RE: Bethlehem Landfill Company
Northern Realignment
Amended Preliminary/Final
Land Development Plan, Site Plan and Lot Consolidation
Our file: b/1162.4/NR/LDP/102620

Bethlehem Landfill Company (“BLC”) hereby submits the following regarding the above referenced project, in response to a review letter issued by Hanover Engineering on September 17, 2020:

CADD FILE: 1162.4-PC-06.dwg
 DATE: 08/10/20
 SCALE: AS SHOWN
 DRAWING NO.

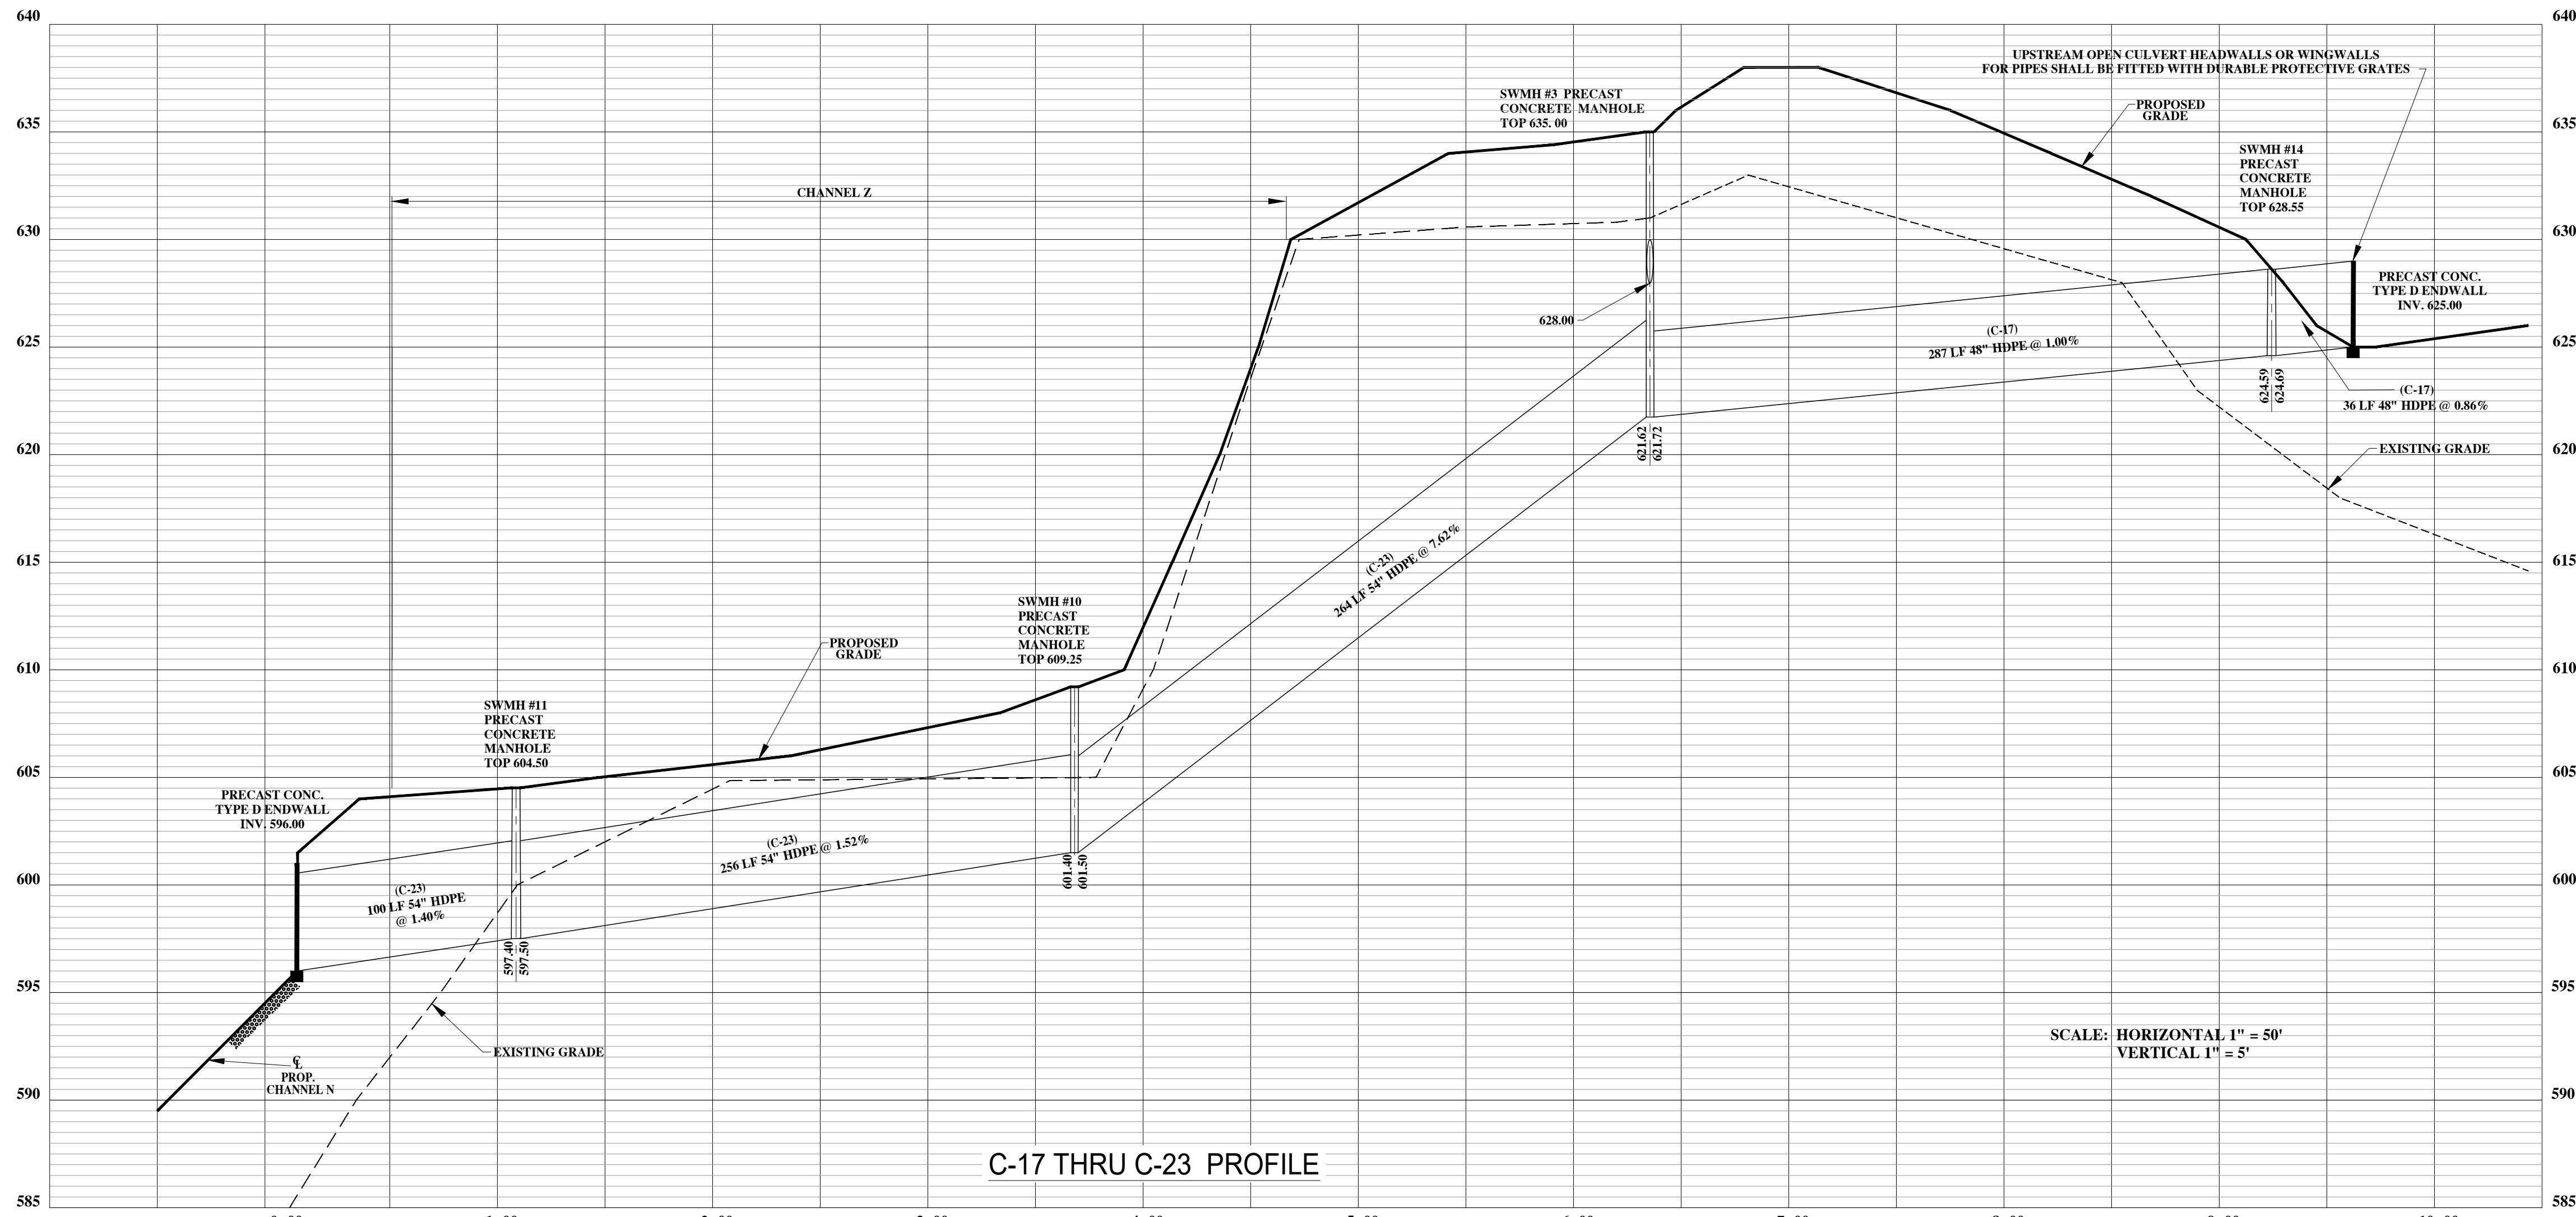
- f. The Channel N, Channel DS-7, Channel DS-8 and Channel DS-9 slopes listed/utilized in Appendix J and listed in the Summary Hydraulic Design of Permanent/Temporary Waterways chart on Sheet PC-6 shall be checked and revised accordingly, as different slopes are listed on Pages J-4,-7 and -8, utilized in the calculations and listed in the chart.

The slopes of all proposed channels have been checked and revised accordingly for consistency between the plans and the PCSM report contained within Section 10 of the Land Development Plan Supporting Documents Binder. Refer to Appendix J of the revised PCSM report and revised Plan Sheet PC-6.

RIVERSIDE DRIVE FUTURE RESERVED
R/W FOR DEED BOOK 830, PAGE 479
AREA = 0.533 ACRES

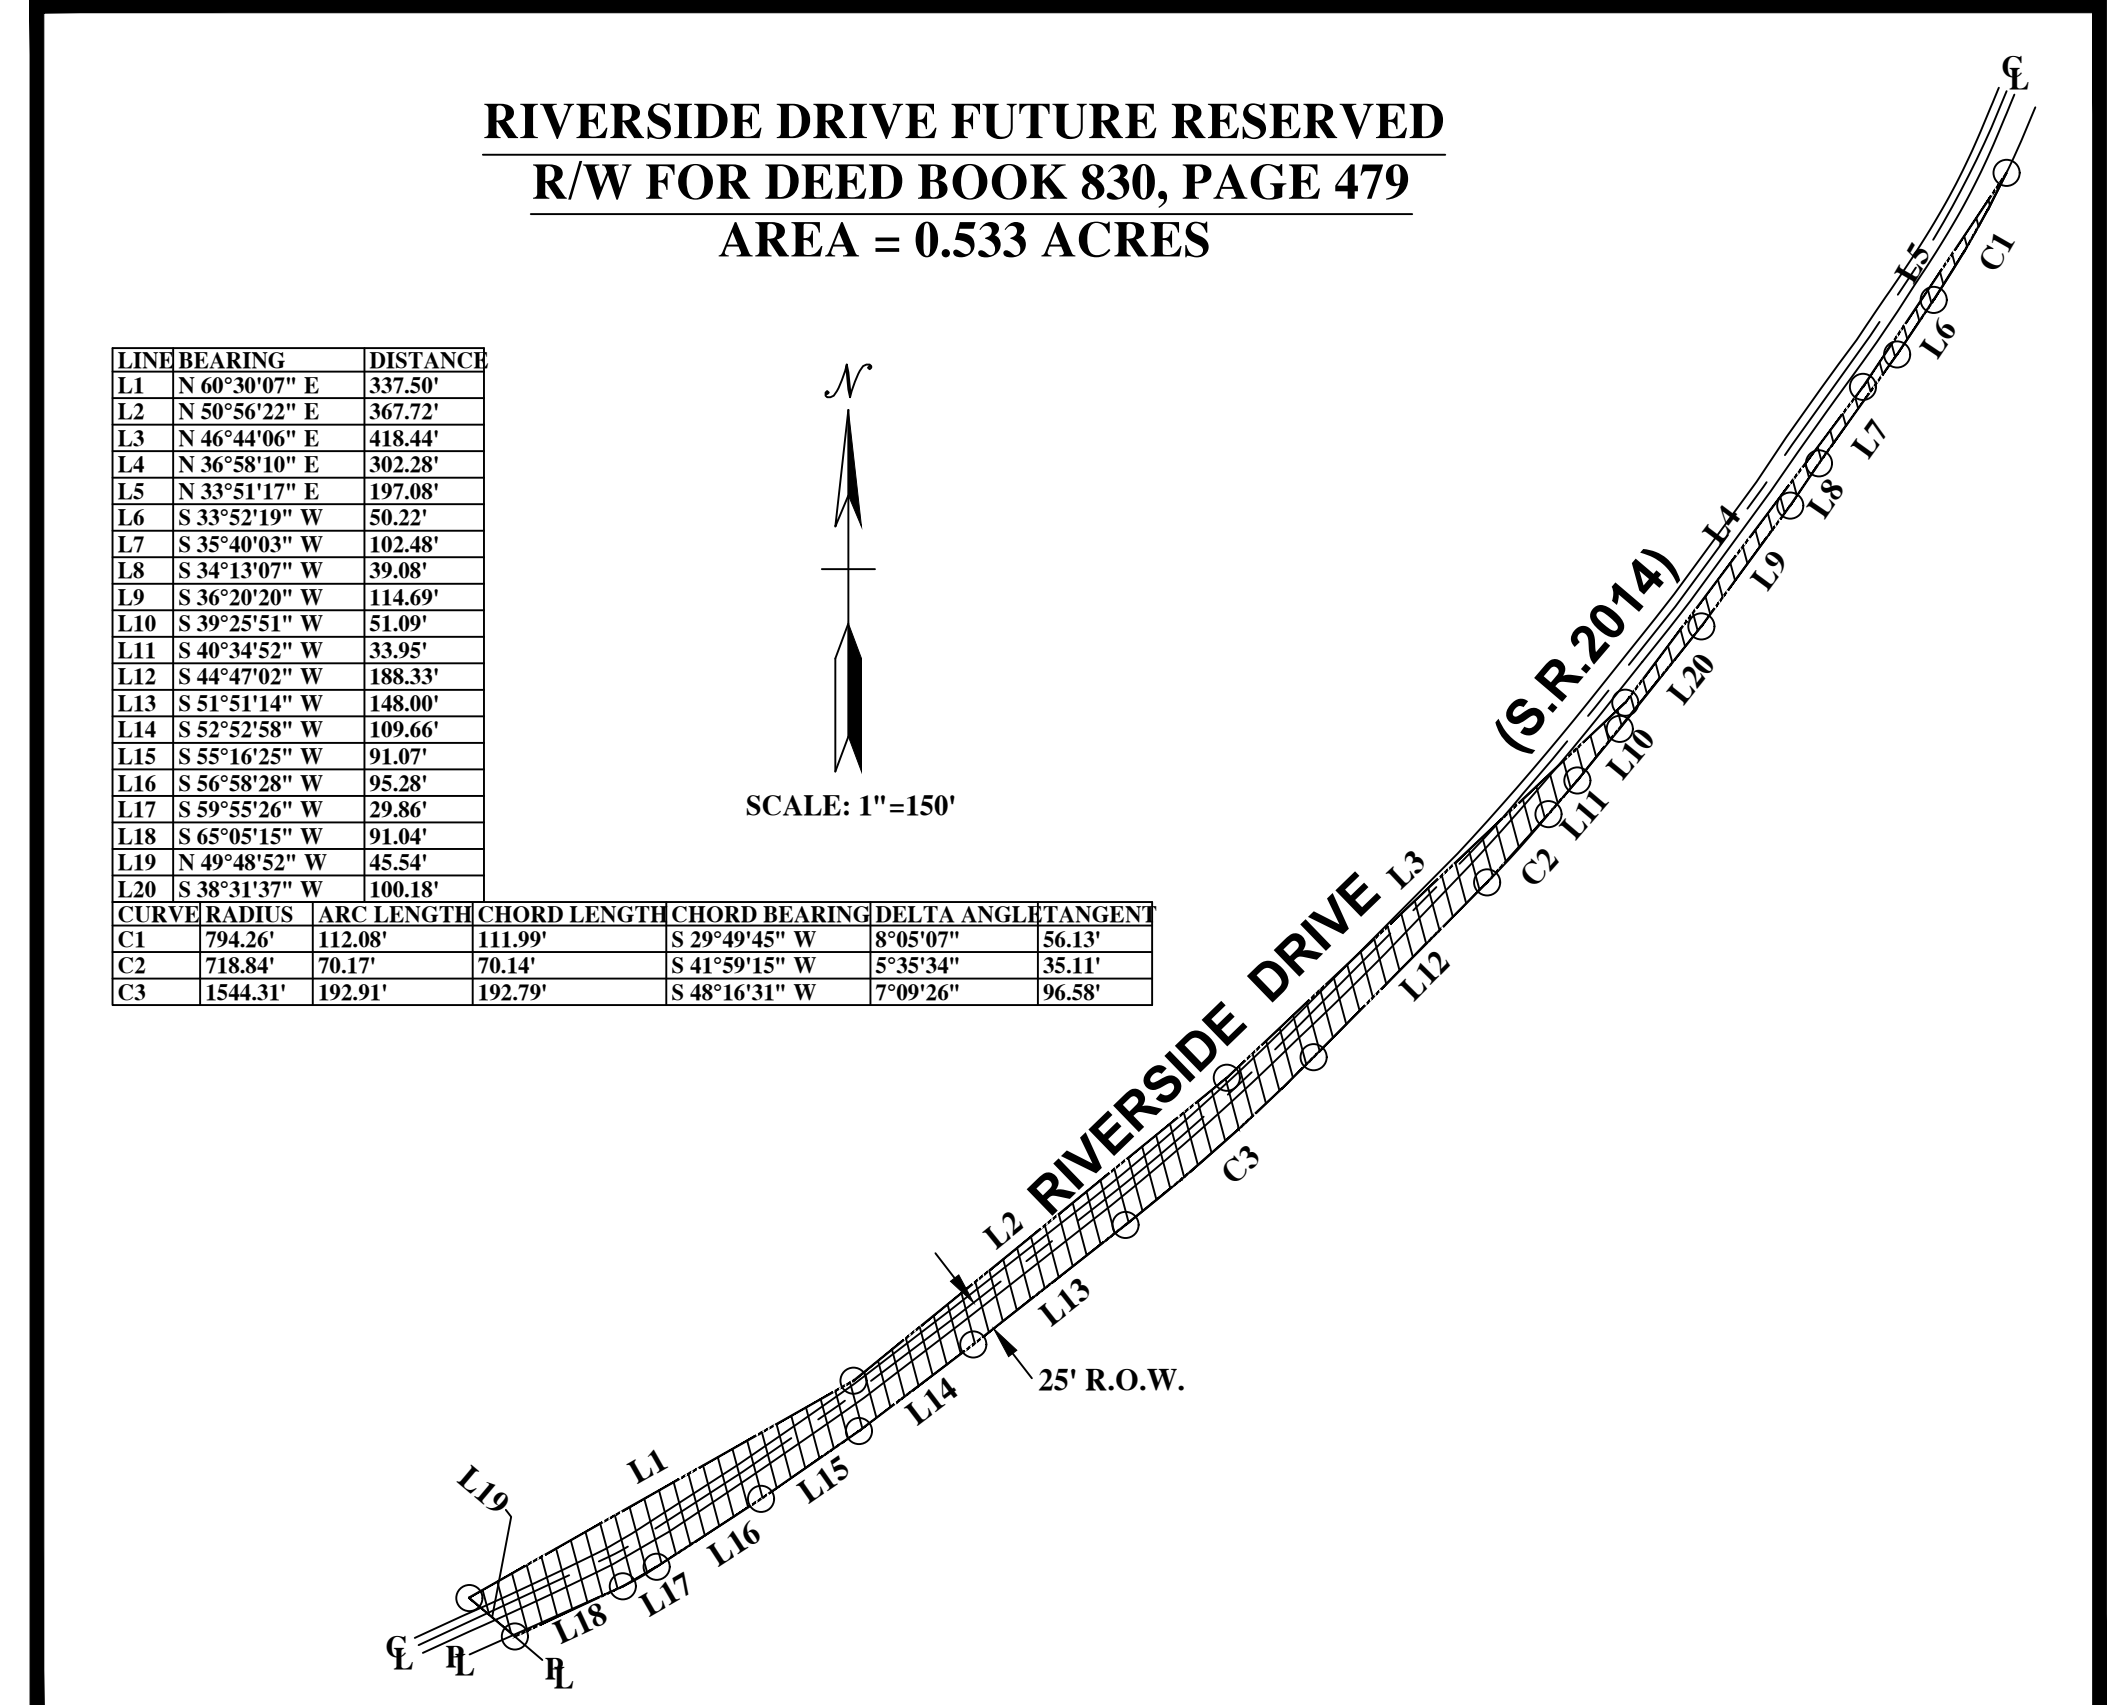
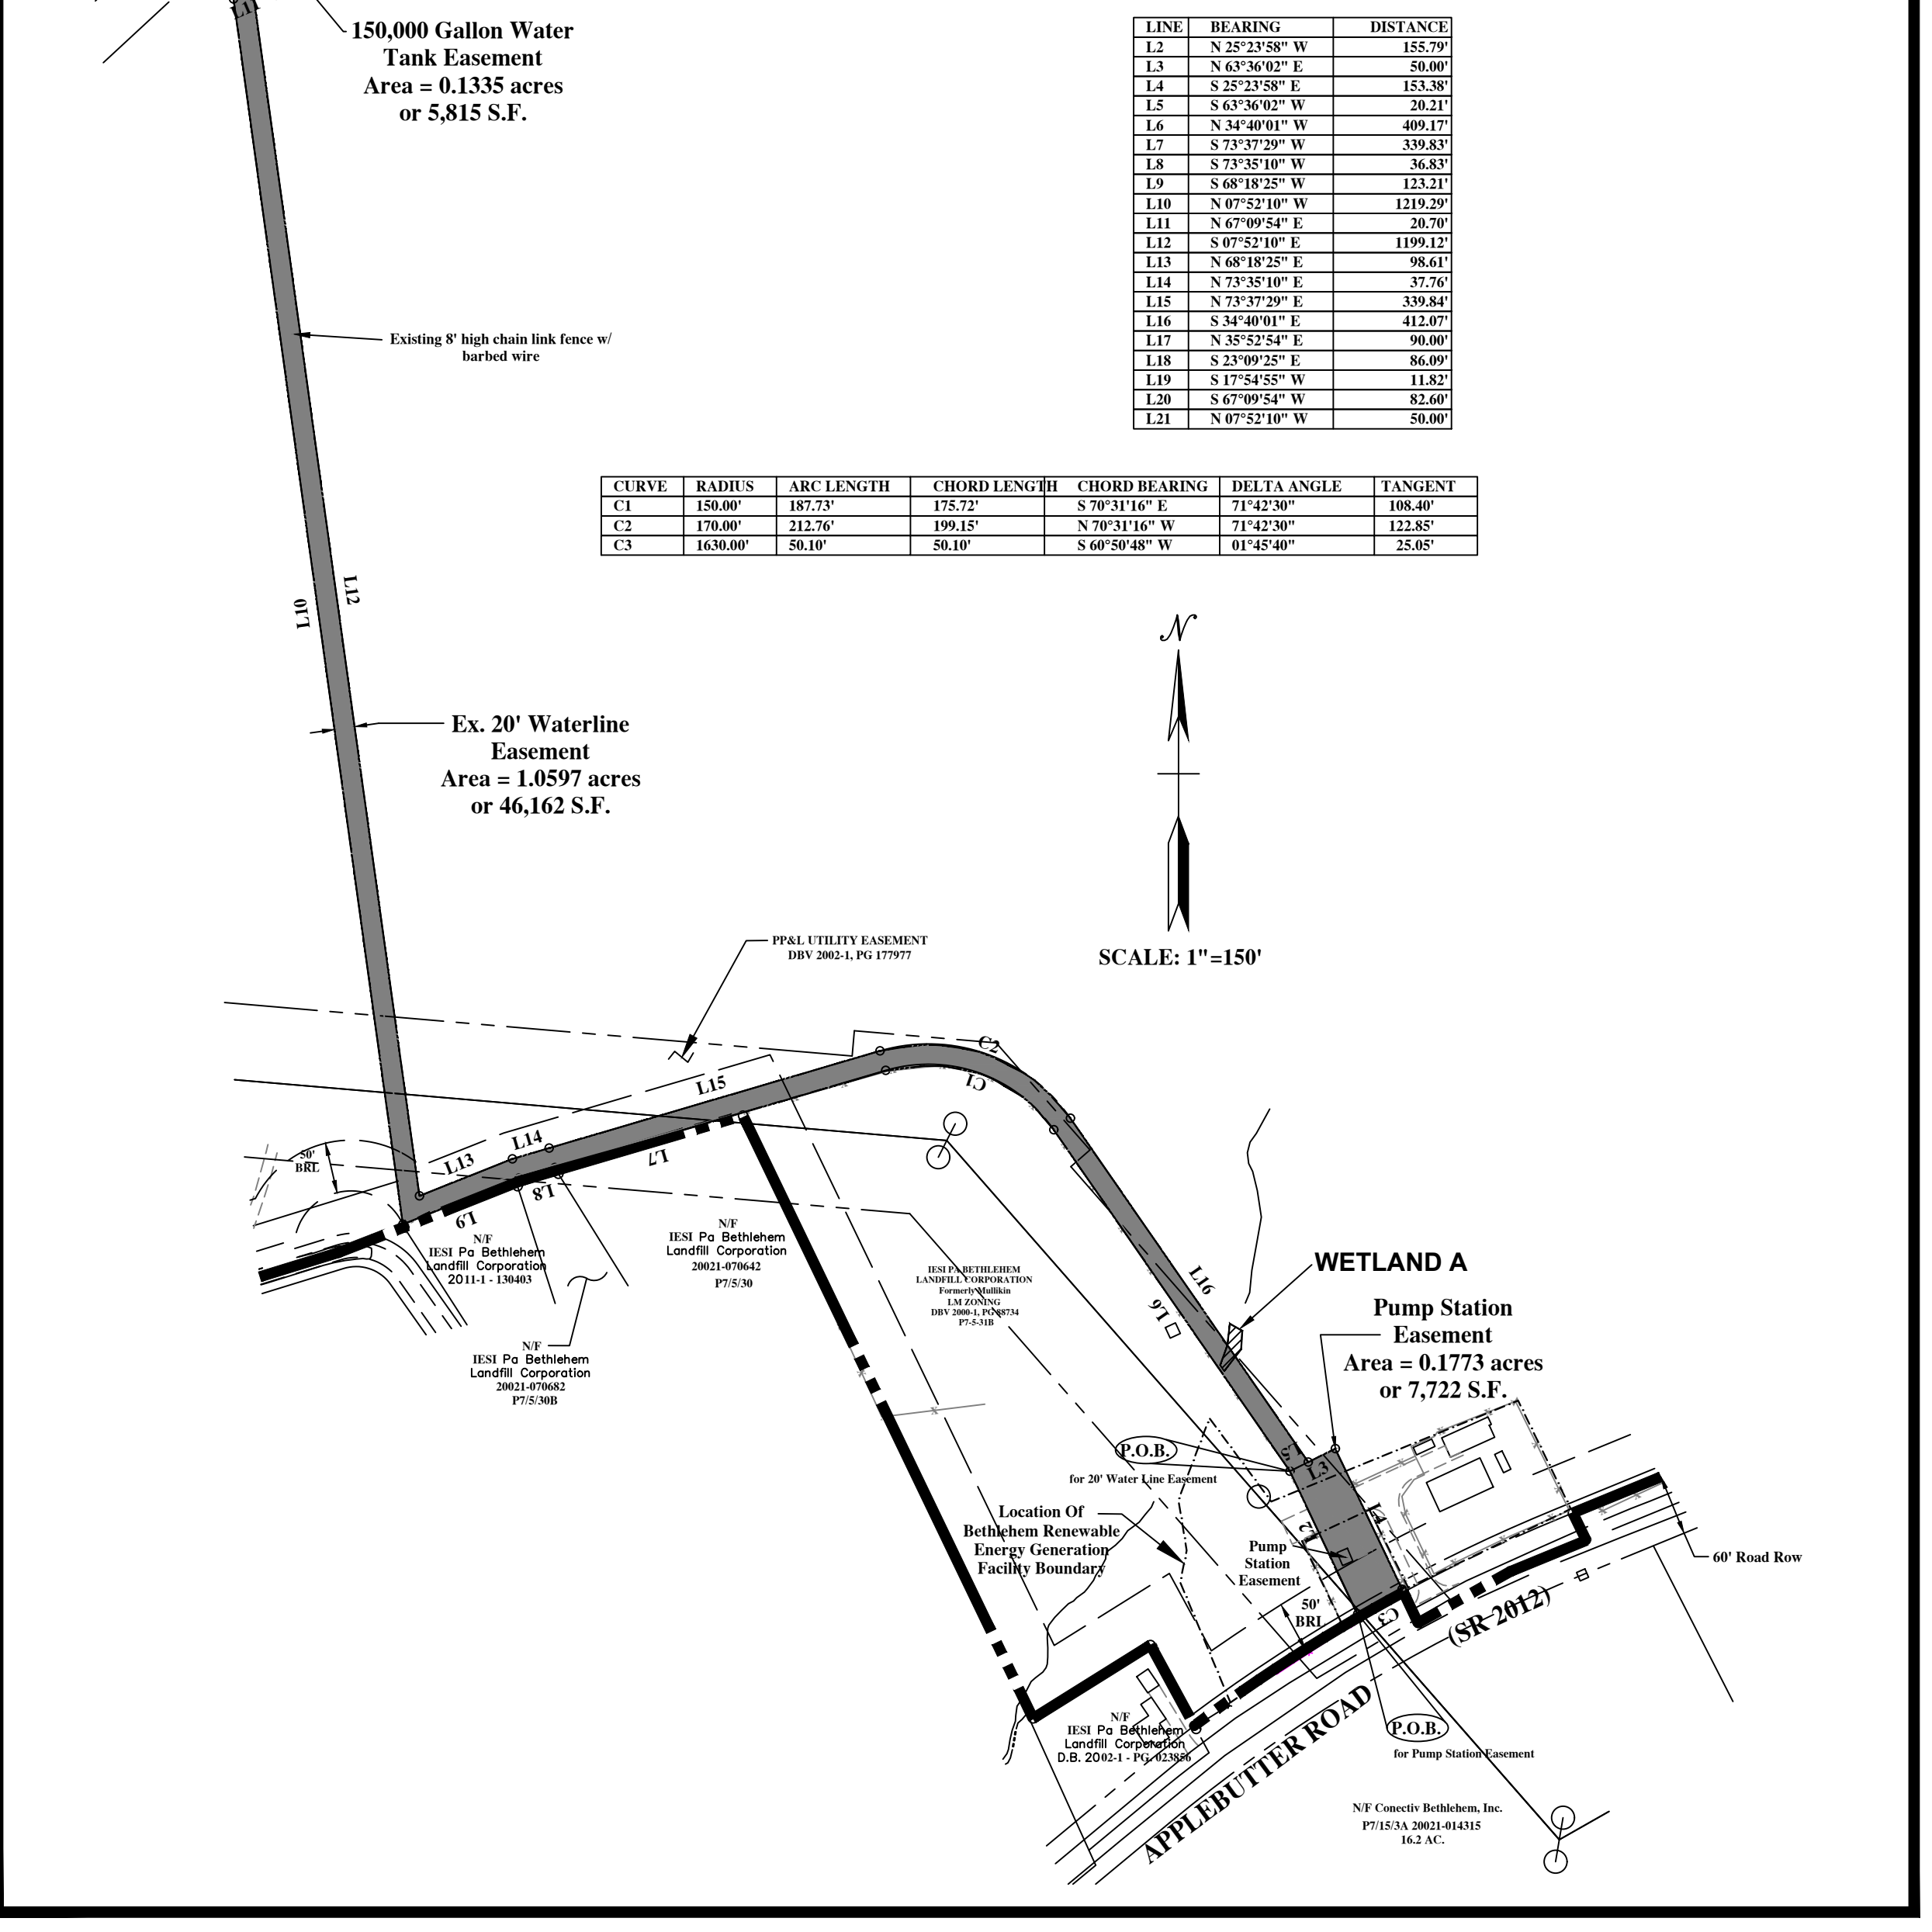
- d. The proposed Riverside Drive right-of-way information is not provided on the Plans; therefore, we cannot confirm the right-of-way area listed on Sheet 2.

- 18. Section 145-33.D.(15) – The following comments regarding the proposed easements shall be satisfactorily addressed:
 - a. Easement line information is not provided for the proposed easements on the former Helms and Redington parcels; therefore, we cannot confirm the easement area listed on Sheet 2.

Plan Sheets #2 and #3 of 17 have been revised to include a bearing and distance description of the ultimate future reserved right-of-way area for Riverside Drive which is located within the area of the consolidated lot.

Plan Sheet #3a of 17 has been added to the set to include details and descriptions of all easements on the former Helms and Redington Tracts.
